Modifications Notices

Mos-Fet Relays

No. 2017167AE(ON)

Changing marking on products for traceability and pin-1 identification improvement of Modification Notice.

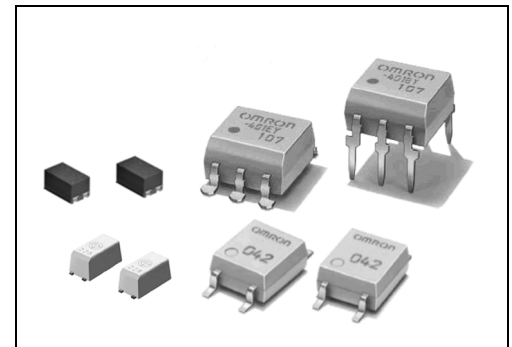
Improvement of traceability and pin-1 identification*.
(*Pin-1 mark changing will be applied SOP only.)

Before the change	After the change
<p>Traceability code None(All models) <Example: DIP4></p> 	<p>Traceability code Add(All models) <Example: DIP4></p> 
<p>Pin-1 mark indication Marked by embossing (SOP only) *The other package models are marked by laser <Example: SOP4></p>  <p>Marked by embossing →</p>	<p>Pin-1 mark indication Marked by laser (All models) Changes Applicable models: SOP4 >> G3VM-□□G□/ G3VM-S□ SOP4 Special >> G3VM-□□V□ SOP6 >> G3VM-□□H□ SOP8 >> G3VM-□□J□ <Example: SOP4></p>  <p>Marked by laser →</p>
